RECALL BULLETIN 05V-261 (Rev. A)

DATE: OCTOBER 7, 2005
 MODEL YEAR: 2002– Certain Early Production 2005 Model Years
 CHASSIS MODEL: UD1200/UD 1300/UD1400
 BULLETIN NUMBER: SC-261
FILE IN THE ELECTRICAL SECTION OF THE TECHNICAL BULLETIN BINDER
 (Discard previous Recall Bulletin dated September 12, 2005)

VOLUNTARY SAFETY RECALL CAMPAIGN NUMBER 05V-261: BATTERY CABLE REPLACEMENT

Figure B1 (2002-2004 MY) Without retaining clamp on Transmission mount, use a Tie Strap PN 01552-00043

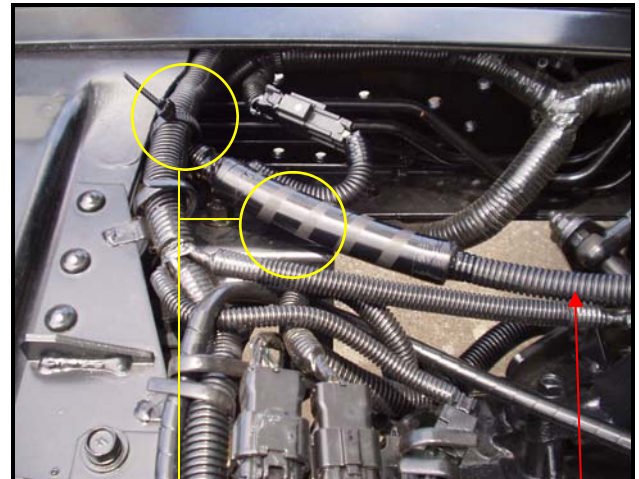
Step 3A (Metal retaining ring missing or broken) Install, route and secure the battery cable to the chassis harness as shown in Figure B1 using a tie strap PN 01552-00043.

Figure B2 (2005 MY) With retaining clamp on Transmission mount

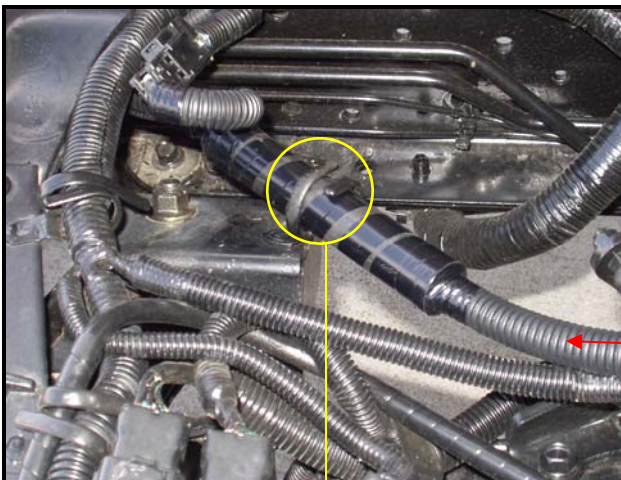
STEP 3B (Metal retaining clip in place) Install, route and secure the battery cable through the welded metal retaining clamp as shown in Figure B2.

Figure C

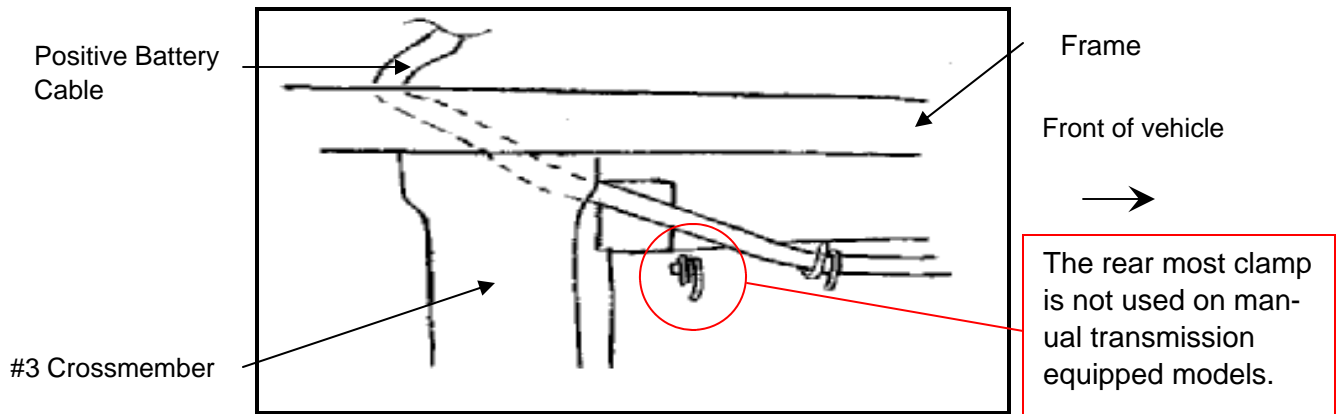
On Manual Transmission Models: Do not use the rear most retaining clip on the transmission shift cover securing the battery cable on manual transmission, see illustration Figure C for details.

Figure D

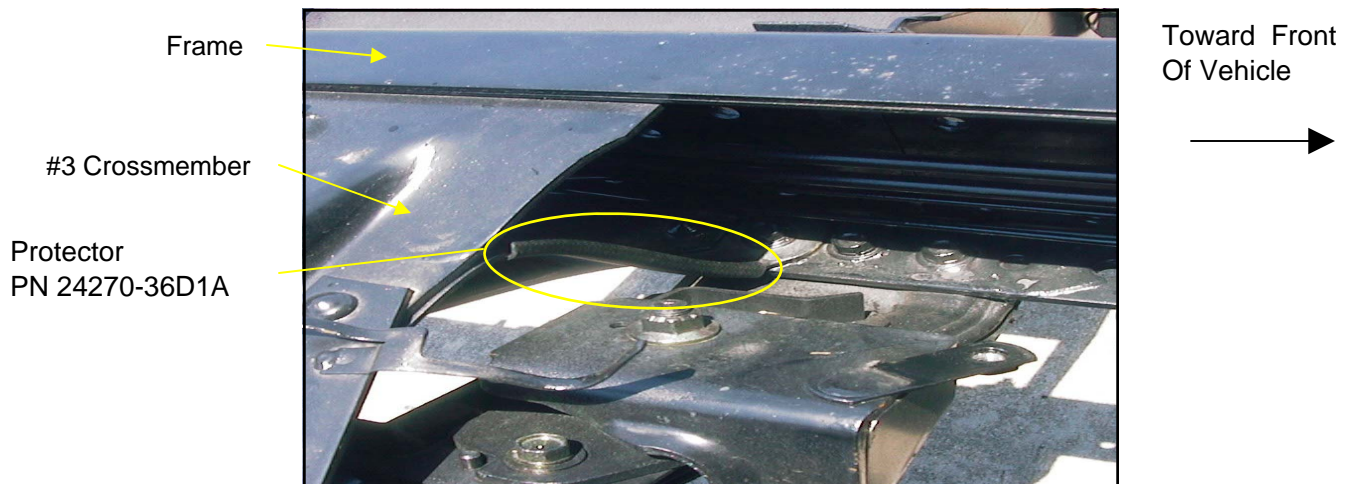
The possibility exists that the positive battery cable between the battery and the starter motor may be damaged or shorted to ground against the edge of the rear transmission support bracket and/or the edge of the 3rd frame cross member. Shorting of the positive battery cable to ground will rapidly discharge the batteries resulting in a no-start condition and could possibly cause a vehicle fire from overheating and melting of battery cable insulation or the corrugated protective conduit.

Install the 3rd Cross Member Protector **PN 24270-36D1A** as shown in Figure D.

Figure E

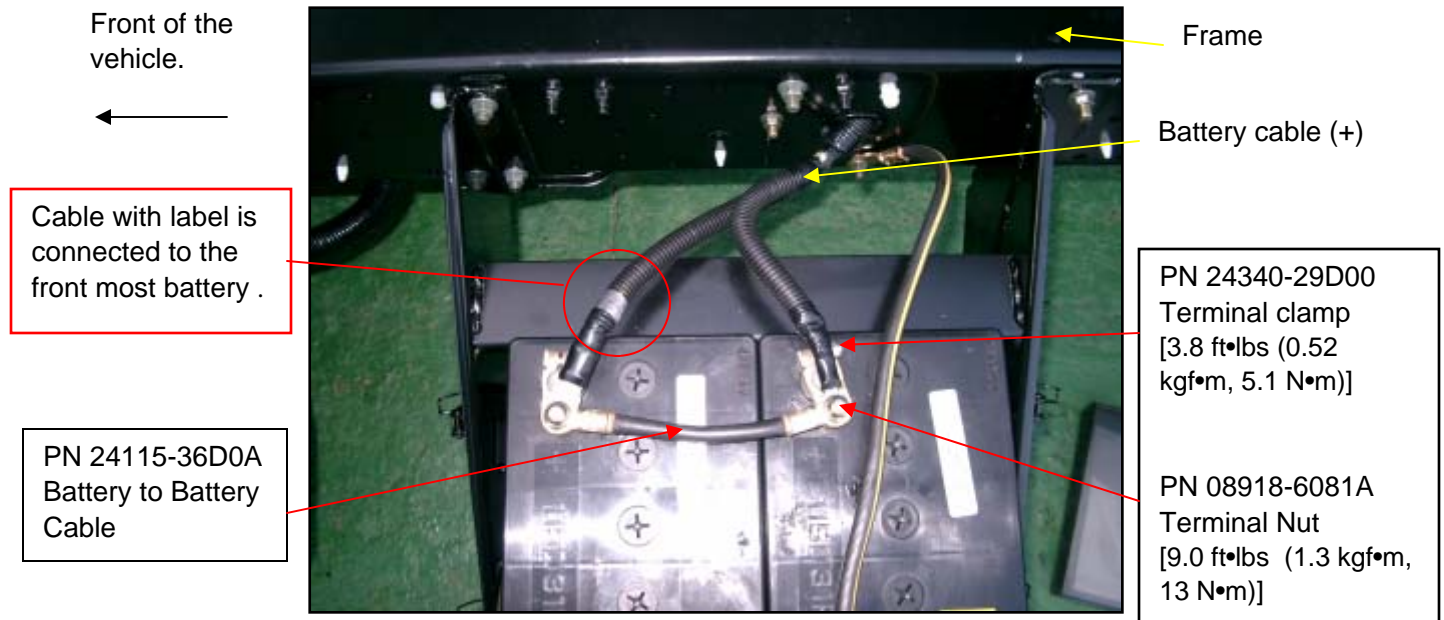
1. Add battery terminal clamp **PN 24340-29D00** to the rear most battery's positive post.
2. Using battery- to-battery cable **PN 24115-36D0A** connect both positive terminals.
3. Attach the alternator feed cable to the rear most battery terminal clamp using nut **PN 08918-6081A** and torque to specifications under References on page 7.
4. Attach the battery cable affixed with a label around the conduit to the front most battery's positive terminal as shown in Figure E.
5. Tighten all connections to the torque specifications under References on page 7.
